# 1963 Corvette: Service Bulletin: Transmission Shift Lever Vibration

**Subject:** Transmission Shift Lever Vibration

**Model and Year:** 1963 1000 Series, Chevy II and Corvette with Floor Mounted Shift Lever

**Bulletin No:** DR #595

FIG. 1

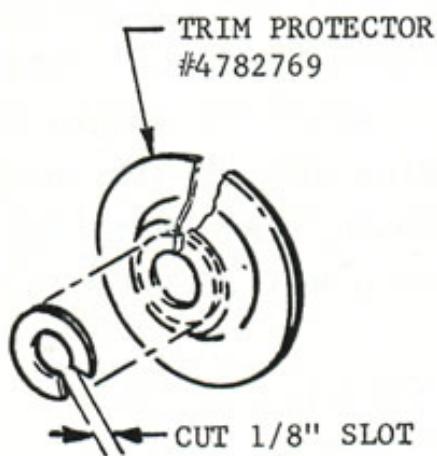
A plastic insulating washer, approximately 1" O.D., fabricated from trim protector No. 4782769 (see fig. 1, below) will be required on all vehicles produced prior to November 15, 1962, when a complaint of shift lever "buzzing" is encountered.

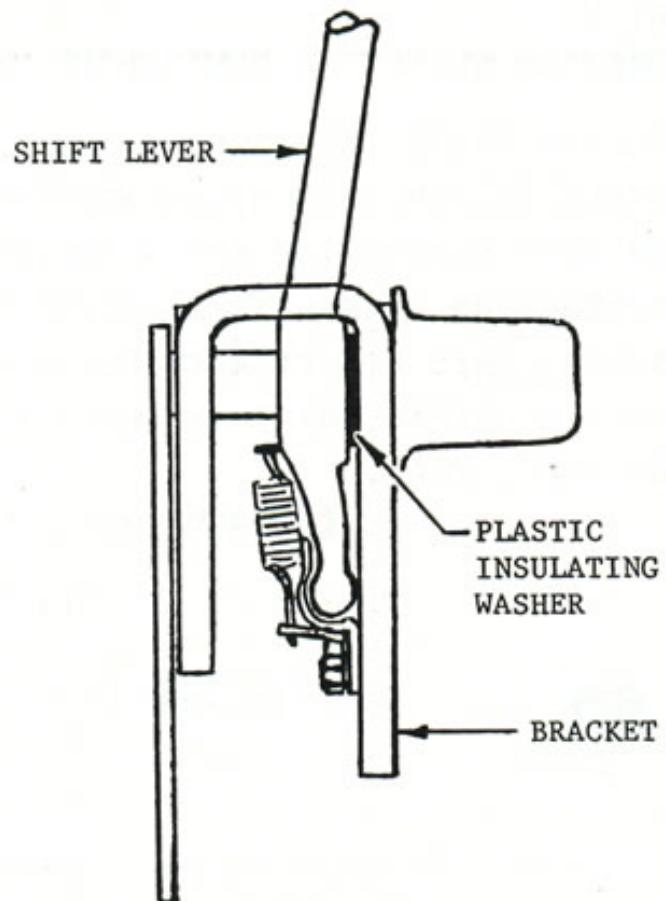
With the shift lever assembly removed from the vehicle, insert the above fabricated insulator washer on the shaft between the lever and bracket. (See Figure 2, below)

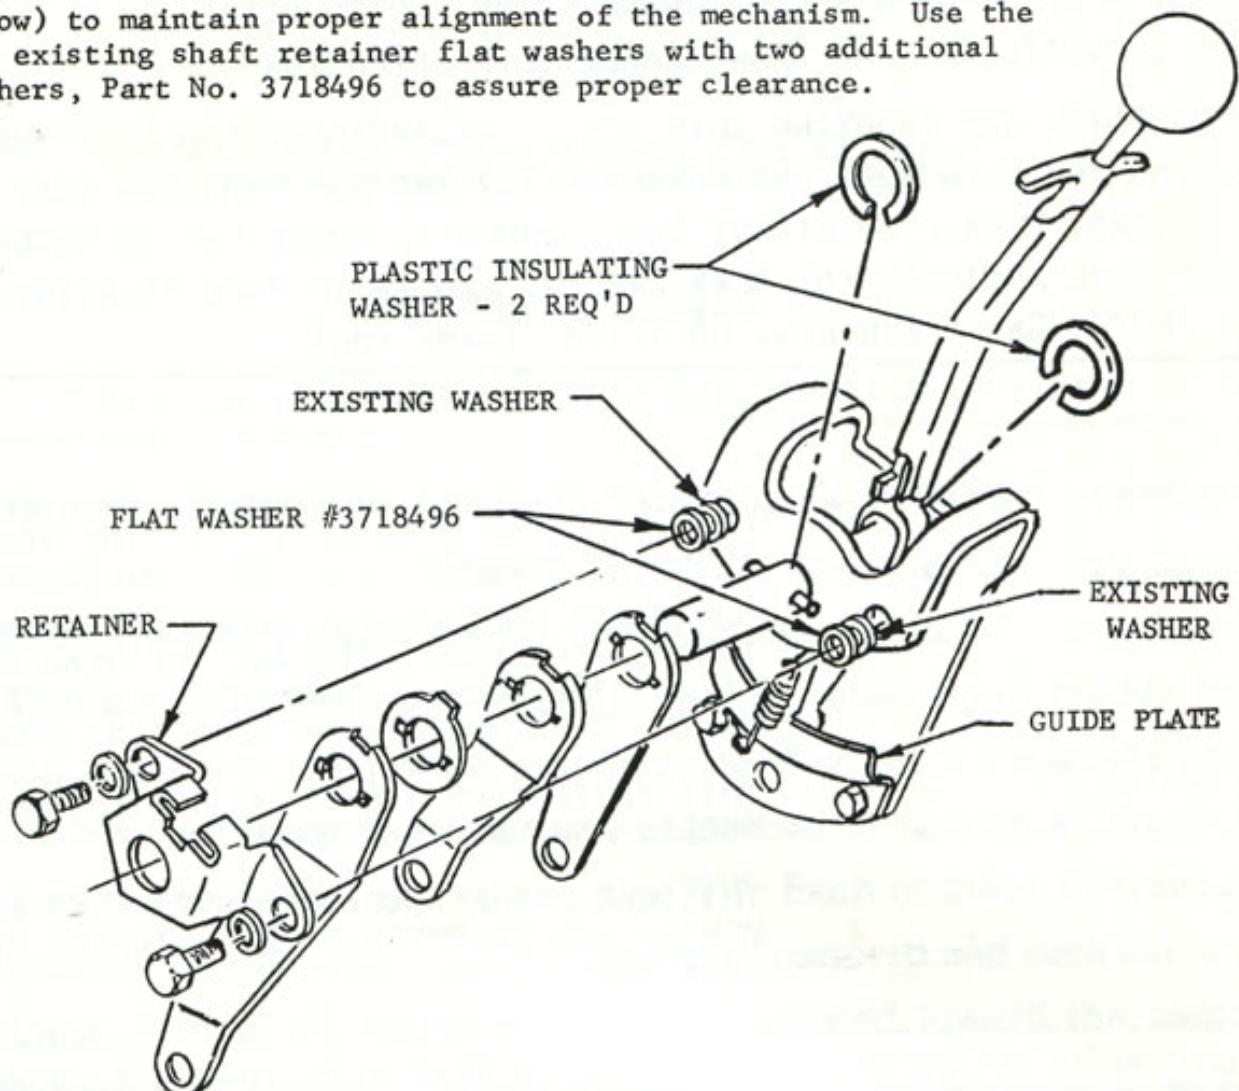
With the shift lever assembly removed from the vehicle, insert one insulator washer between the lever and bracket and another insulator washer between the bracket and pin, (See Figure 3, below) to maintain proper alignment of the mechanism. Use the two existing shaft retainer flat washers with two additional washers, Part No. 3718496 to assure proper clearance.
